IMMINGHAM EASTERN RO-RO TERMINAL

Consultation Report Addendum (Appendices K – M)

Document 6.1.1

Appendix L: Consultation responses taken into account

Figure 2 – Proposed realignment of the Approach Jetty and related works

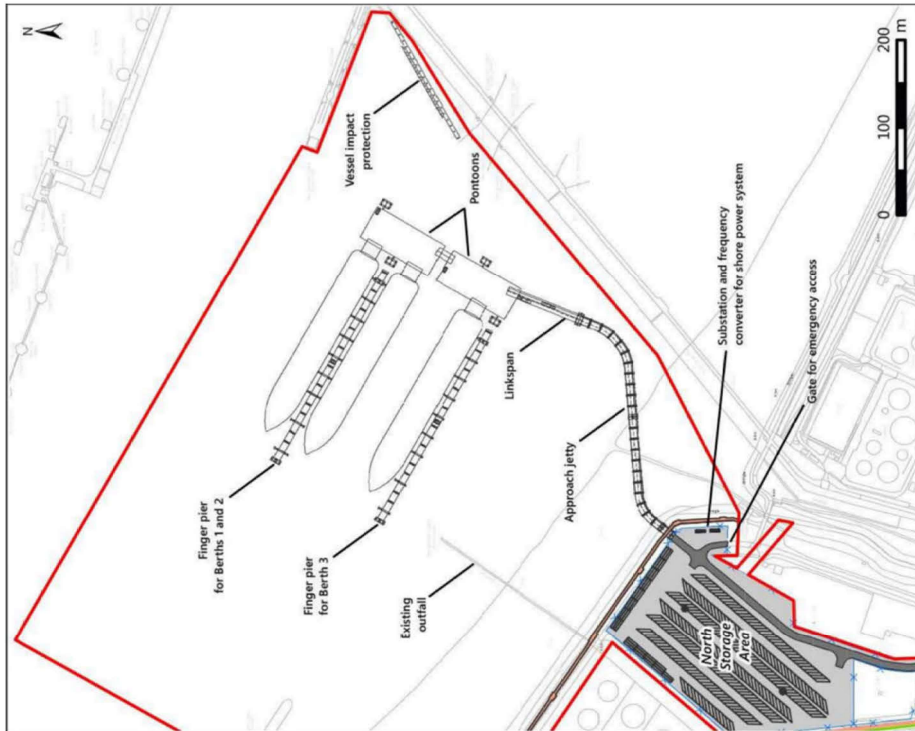
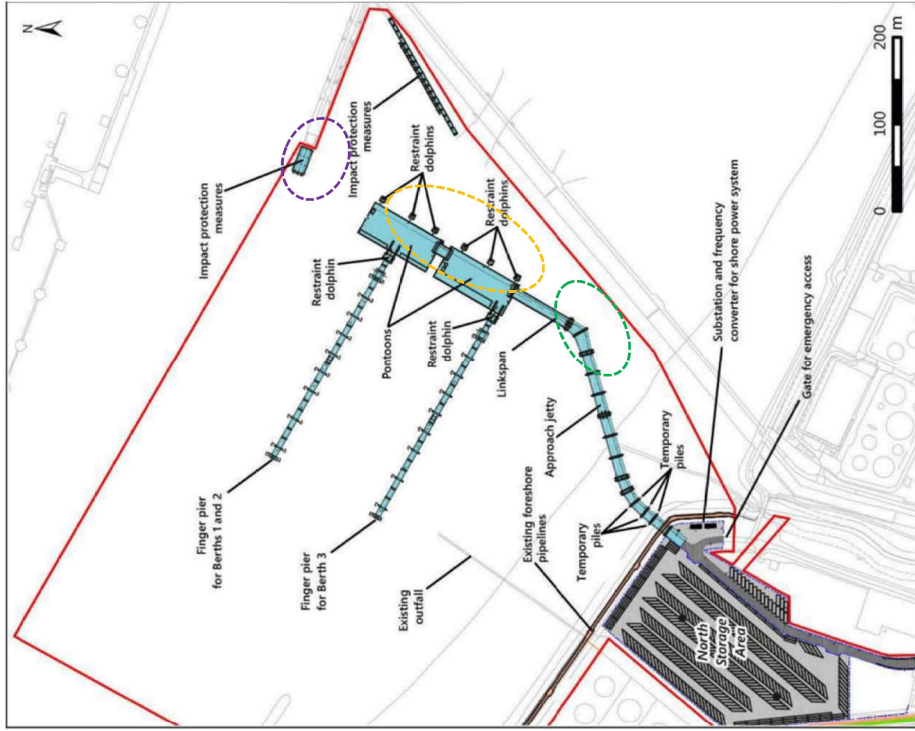
- 2.1 At para. 2.13 of the change request **Restraint dolphins** are included, which the Applicant ABP notes include up to two additional restraint dolphins for each of the landing pontoons to improve stability. These are identified in "*Figure 2 – Proposed realignment of the Approach Jetty and related works*" – see figure above with restraint dolphins identified by orange pecked line. At Section 3.1 of the Change Request, which describes the "Rationale and Need for the Changes", restraint dolphins are conspicuous by their absence and as such no details are provided by the Applicant justifying the need for restraint dolphins.

- 2.3 The IOT Operators welcome the inclusion of restraint dolphins in the change request, and the implicit acceptance that the IOT Operators sNRA findings in this regard is correct.

- 2.4 However, the IOT Operators' are not able to understand:
- (a) The calculations which have informed the design details which are being used in the Applicant's change request; or

- 2.5 In its change request the Applicant does not explain the purpose of the additional restraint dolphins. The IOT Operators have repeatedly requested information and detail (from first engagement on the project in Feb 2022 through to Examination Deadline 5) on the design of the IERRT and its ability to withstand the allision of an errant IERRT vessel. Most recently, the IOT Operators have requested such detail during the three design workshops. During these design meetings, Ben Hodgkins (ABP Group Head of Projects) noted that details would be provided on the ability of the IERRT infrastructure to withstand an errant vessel in due course, however no details have yet been provided.

- 2.6 Without the justification behind the design basis for the change to include additional restraint dolphins to the pontoons, the IOT Operators assume that the inclusion of the restraint dolphins, if constructed, would be to provide additional “implicit” impact protection to the IERRT structure, and as such provide additional protection to the IOT Trunkway. Therefore, IOT Operators require both the engineering design and impact loading parameters to be provided showing what the effect the restraint dolphins have on mitigating allision of an IERRT vessel with the IOT Trunkway, and separately mitigate the risk of the pontoons from becoming detached such that they may collide with the IOT Trunkway. It is also noted that para. 2.210 of Appendix 1 notes that the pile size of the restraint dolphins is proposed to be increased from 1,422mm to 1,520mm.

- 2.9 At para. 2.14 the Applicant notes that two additional piles to support mooring bollards have been added to improve mooring performance. The IOT Operators note that, as with the restraint dolphins, no details are provided by the Applicant to justify the inclusion of these additional piles. To date, no details other

- 2.10 The IOT Operators therefore seek that the Applicant provides, or is required to provide, evidence to support this change and, if it relates to navigation safety, then a commensurate update in the Applicant's NRA to address the change.

Figure B – Humber revised unaccompanied RoRo demand and capacity comparison ('000s units)

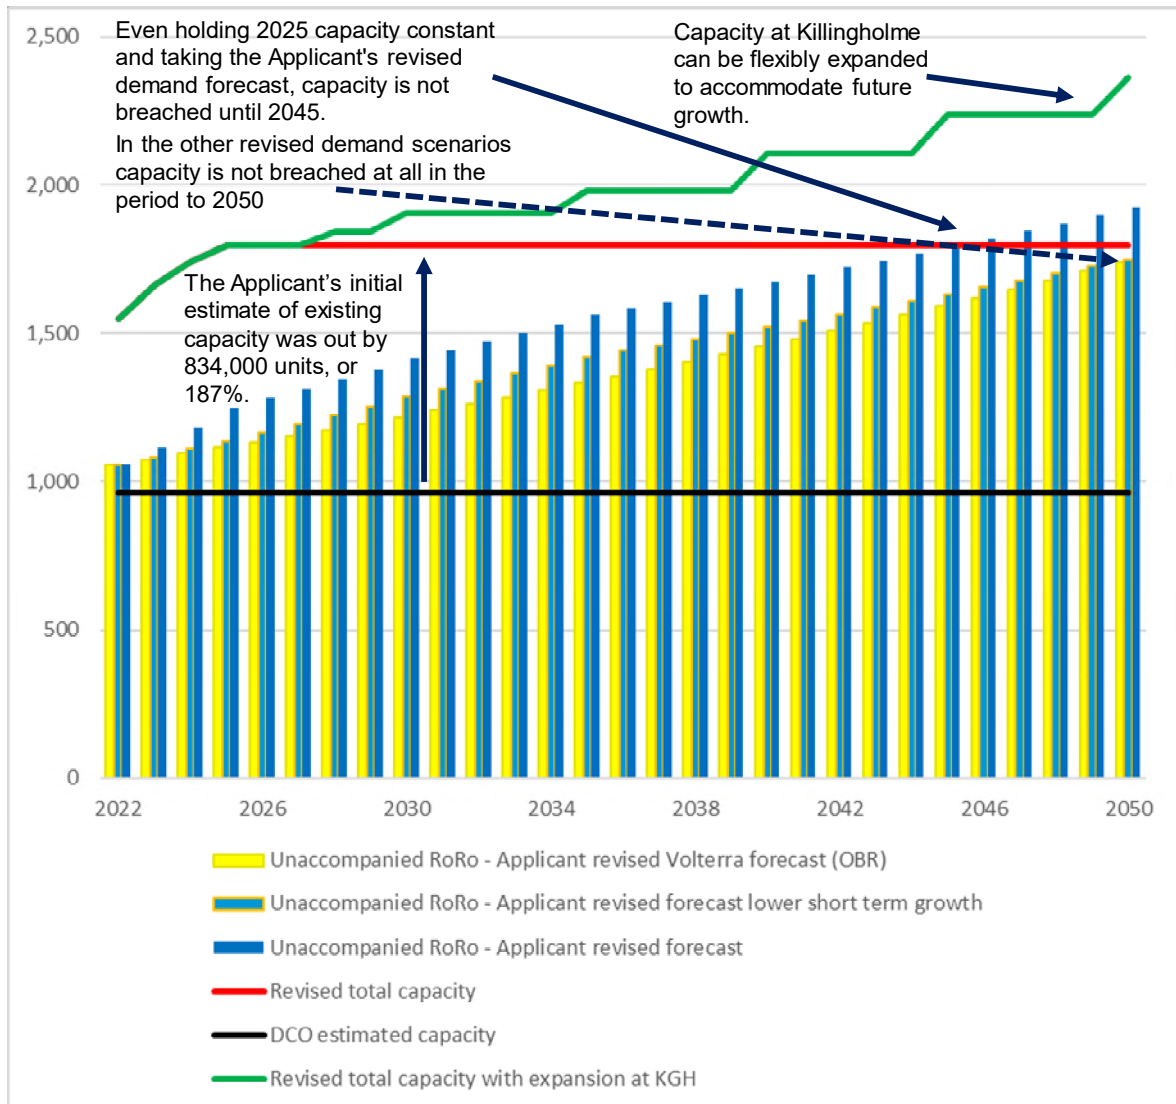
- 2.21 Fundamentally this shows very clearly that there is no 'urgent and imperative' need for the Proposed Development.
